## **3 RESPONSE TO COMMENTS**

This chapter provides a complete copy of all the written comments received on the draft environmental impact report (DEIR) for the Bidwell Park Master Management Plan Update (BPMMP), including the four site-specific Park Improvement Projects at Bidwell Park (Park). Comments from the public hearing held on June 13, 2007 are also included. This chapter also includes responses to significant environmental issues raised in the comments, as required by the California Environmental Quality Act Guidelines (State CEQA Guidelines) Section 15132.

Bidwell Park Master Management Plan Update  
State Clearinghouse (SCH) Number: 2004102045

Exhibit 3.1.3-5

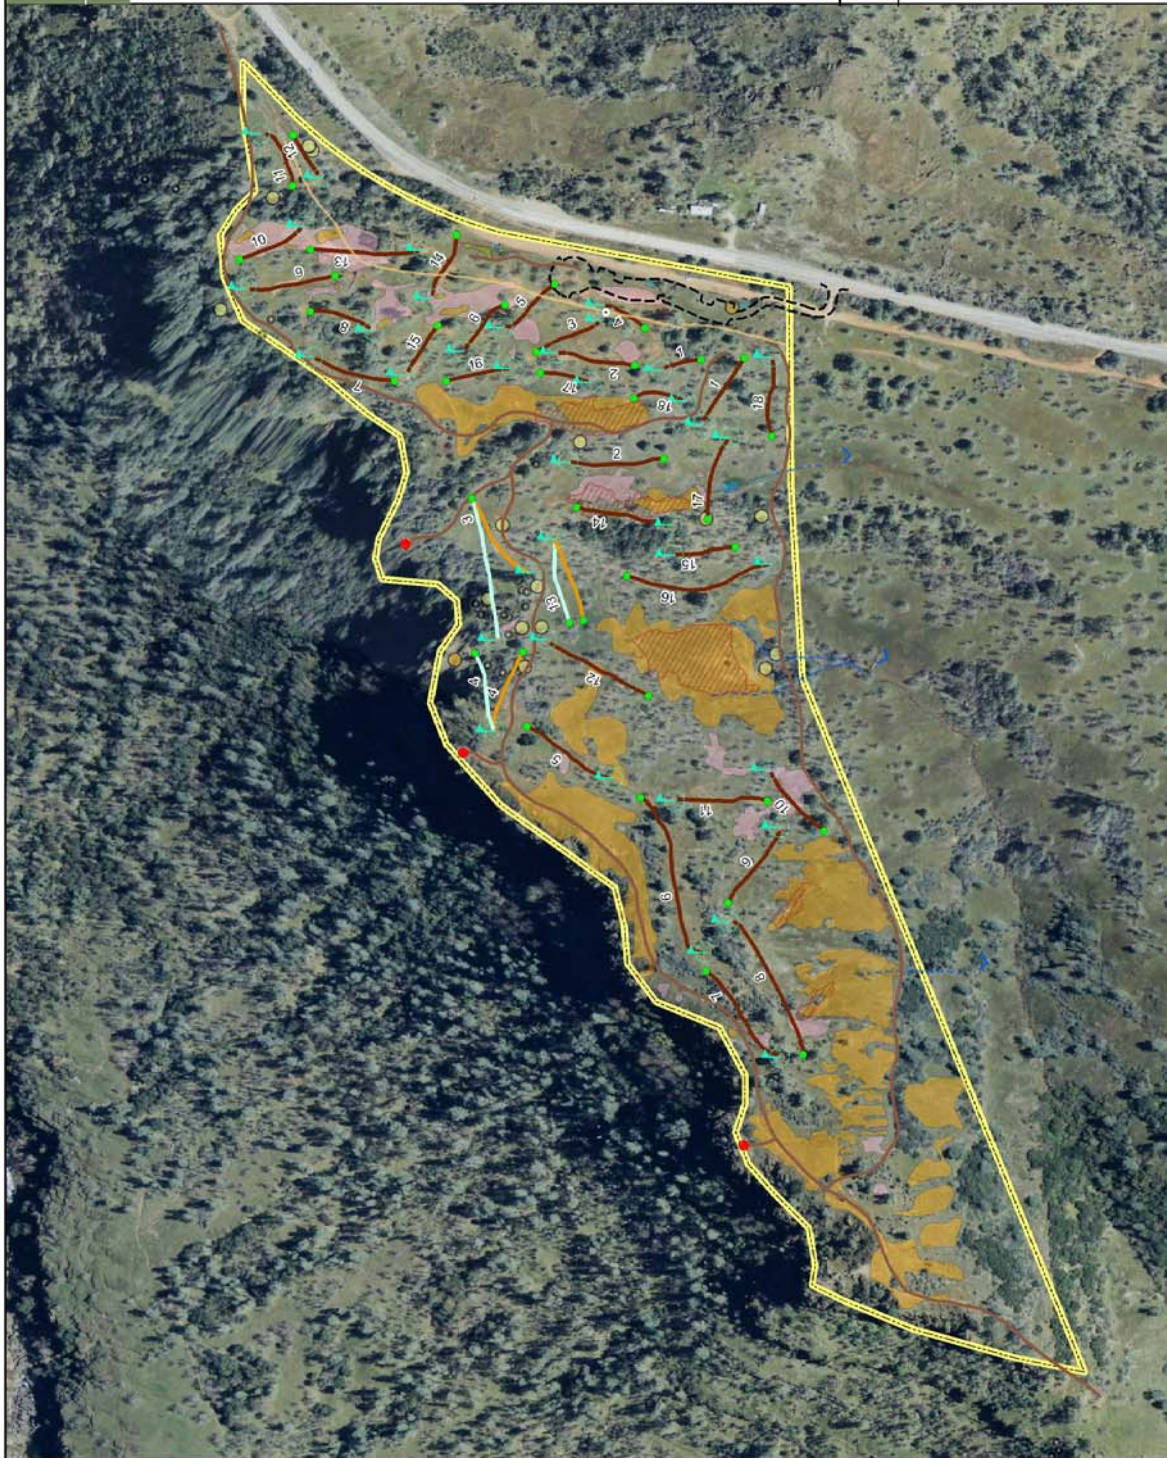
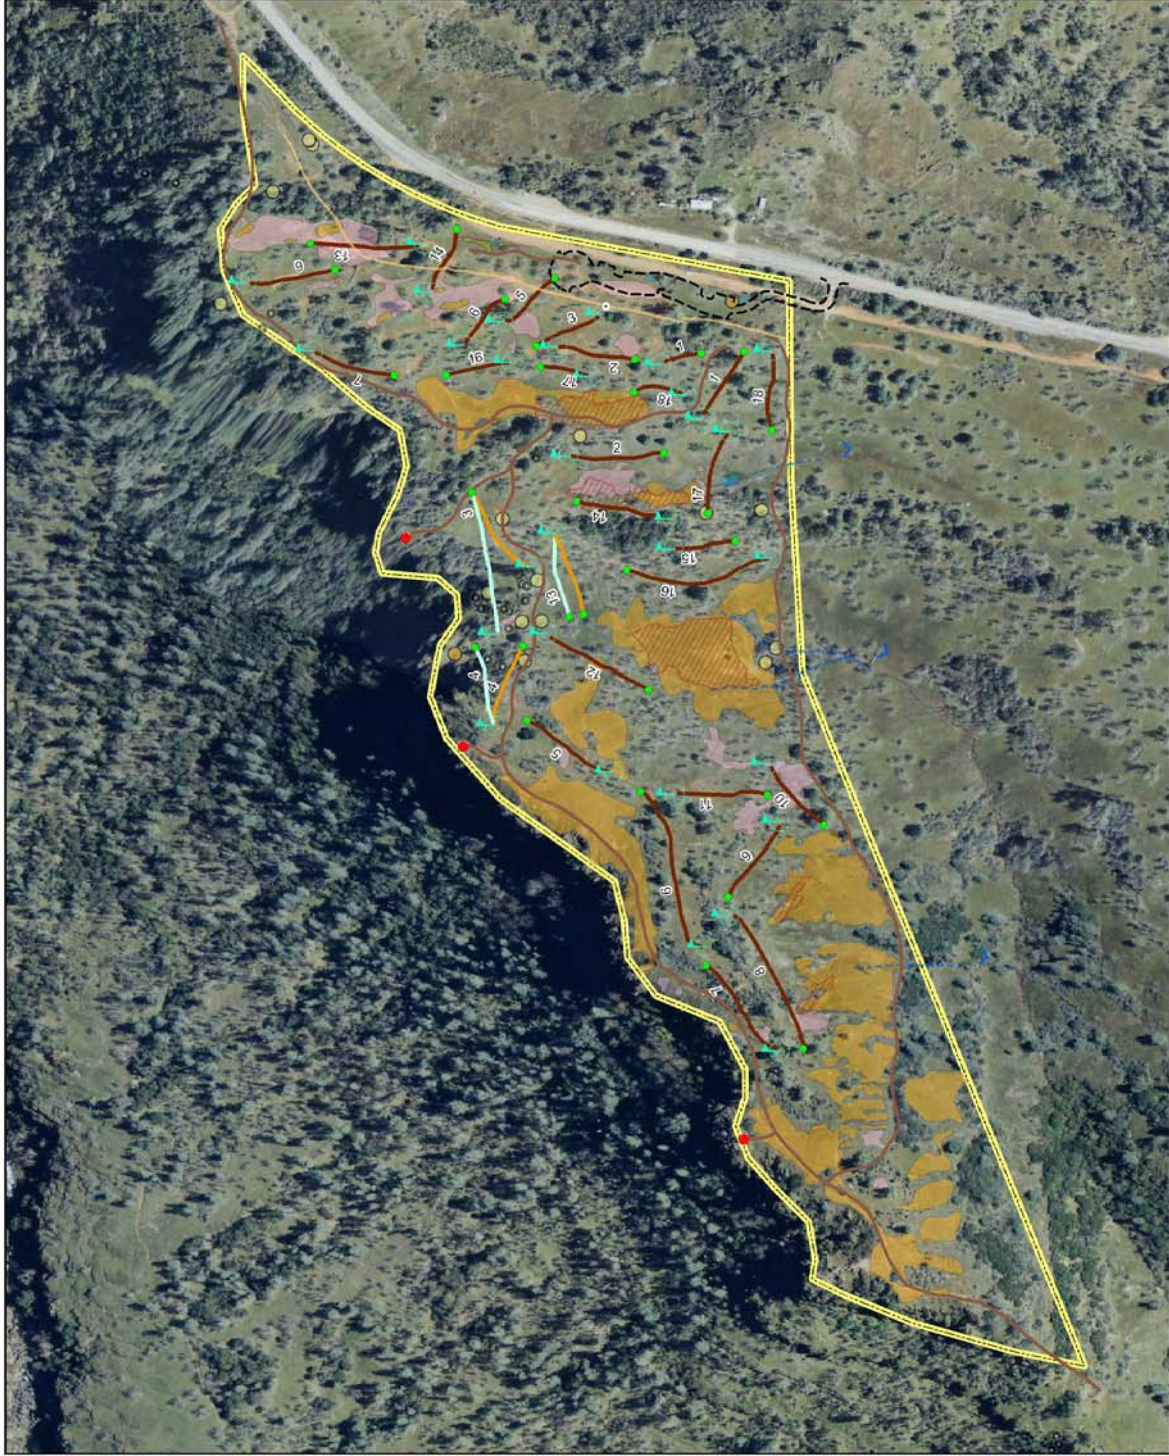
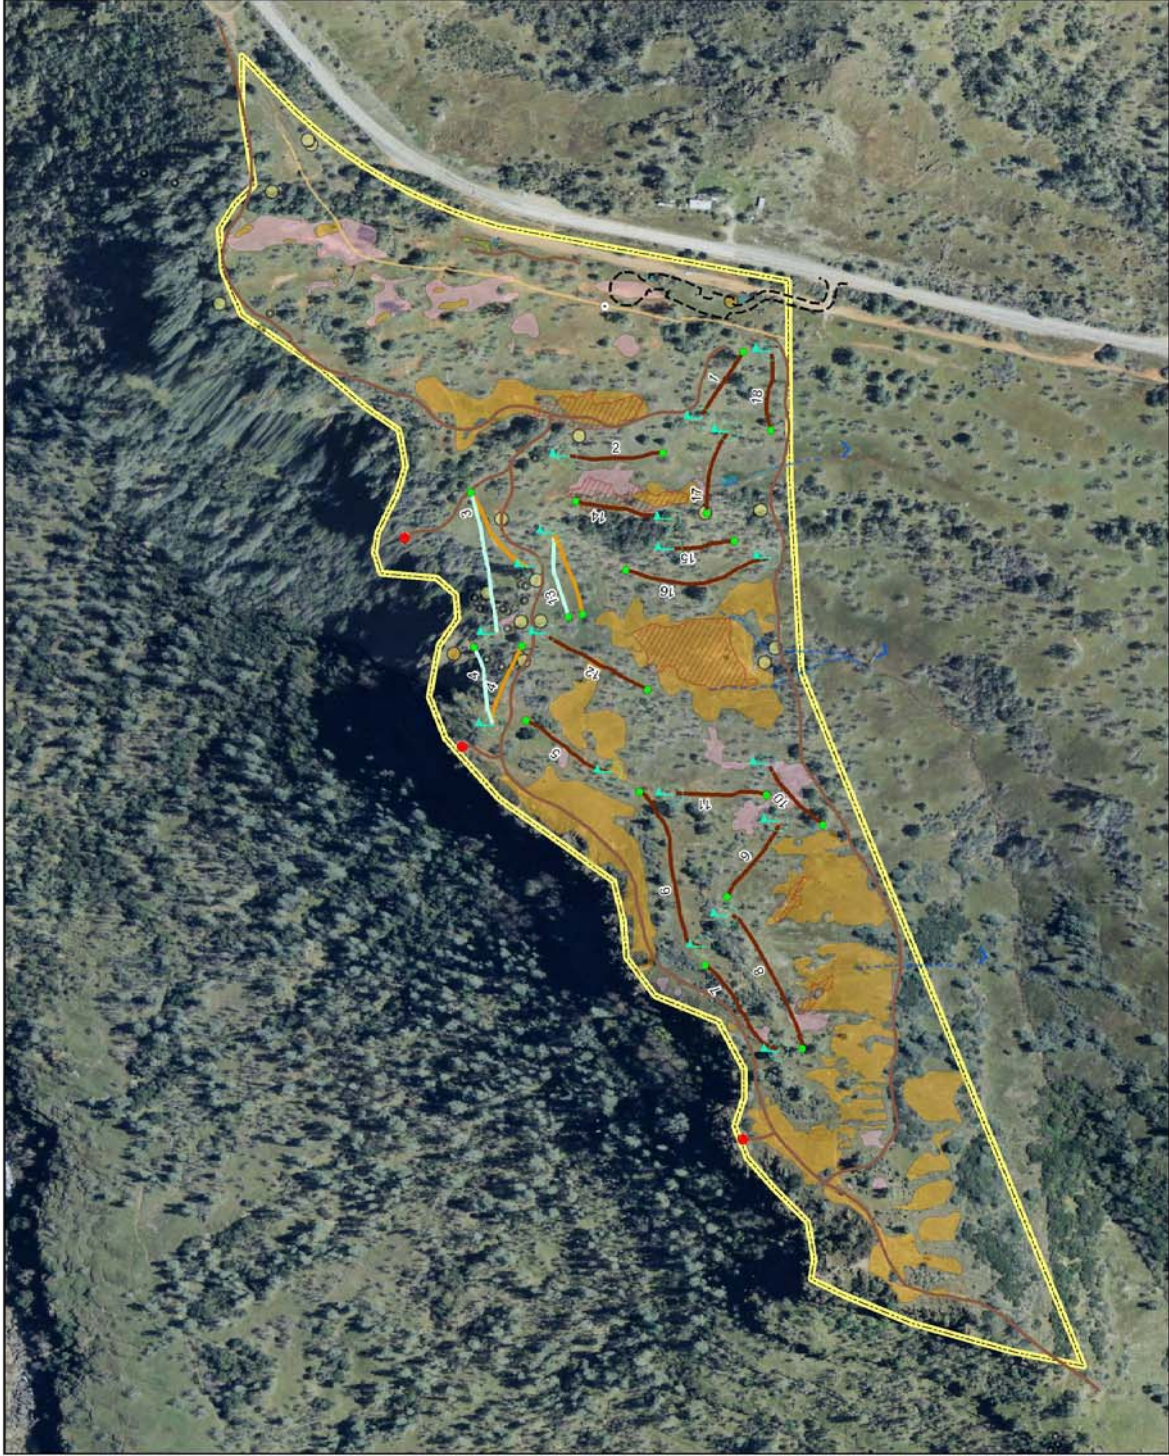
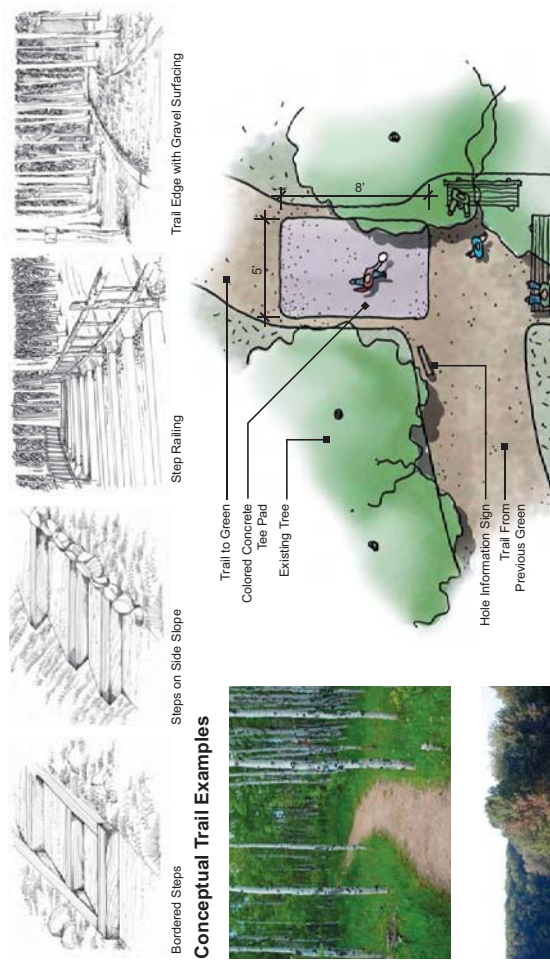
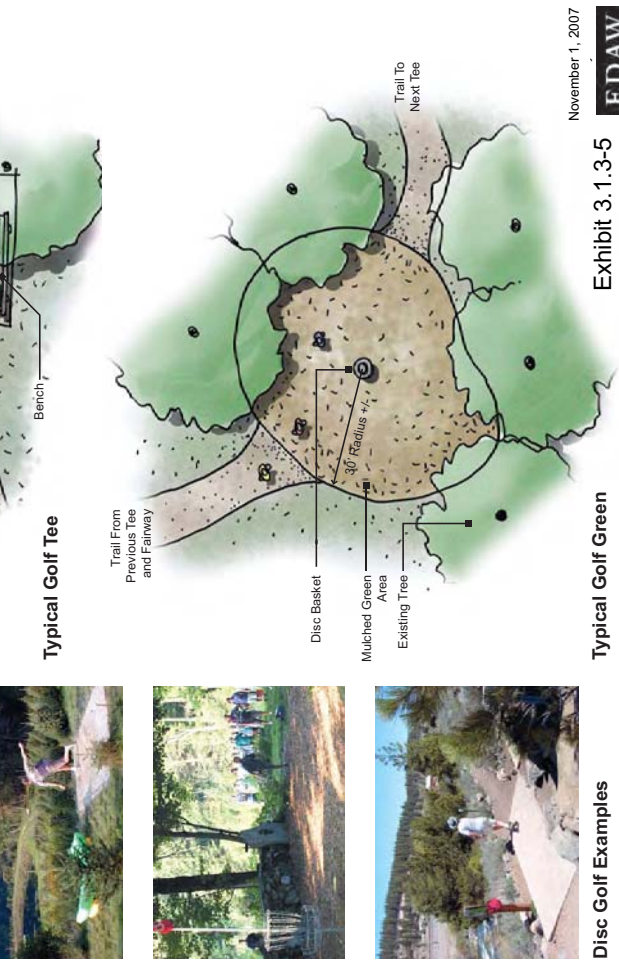
In response to this direction, an additional site assessment to further refine the precise interaction between the Disc Golf/Trailhead area improvements and Humboldt Road was conducted subsequent to public circulation of

To completely avoid direct encroachment, and therefore direct impacts, on the Humboldt Road resulting from the proposed project, the Disc Golf/Trailhead Area design team redesigned the location of the proposed parking lot and associated facilities to completely avoid the recorded location of the Humboldt Road. Exhibits 3.1.3-1 through 3.1.3-5 present the revised design.

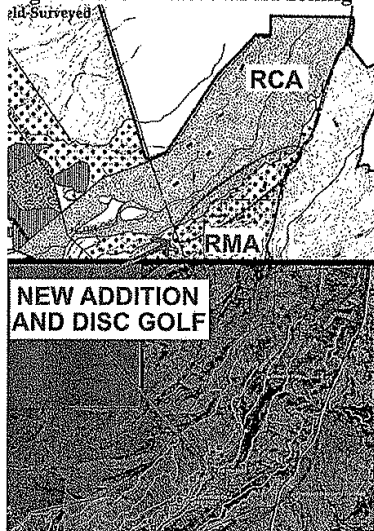
**Option A “Preferred Alternative” (18 hole advanced course and 18 hole beginner course) -** The highway 32 site has a zoning overlay as a resource management area (RMA) versus the remainder of Bidwell Park which is considered a resource conservation area (RCA). Even if the site was zoned RCA it would be consistent with the General Plan and existing uses of OS-1 and RCA zoning to build a disc golf facility at the highway 32 site. Multiple EIRs and botanical studies, as well as multiple disc golf course designs have been evaluated for the BLM site. The first course design consisted of 45 disc golf holes. There currently exist 39 disc golf holes at the site. The largest disc golf option (option A), which was the “preferred alternative” as selected by the Bidwell Park and Playground Commission and the BPMMP CAC maintains 36 disc golf holes. Option A reduces the area used by disc golfers by 30-40%. Option A protects Bidwell’s Knotweed, Butte County Checkerbloom, and reduces soil compaction around Blue Oak trees. This is also the only option that both meets the “project objectives” and meets the needs of the existing user base.

- I27-1 The commenter supports Option A as the Preferred Alternative and discusses shortcomings of the Restoration Alternative. The commenter also questions why no restoration alternative was studied for the other proposed Park Improvement Projects.

**Figure 3 Bidwell's Knotweed that was bulldozed during cleanup**

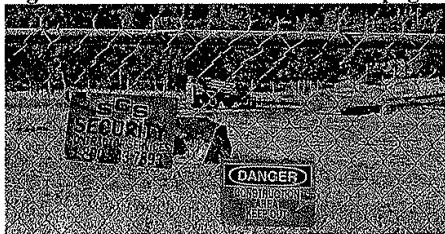
**Figure 2 Construction for lead cleanup ignored Bidwell's Knotweed**
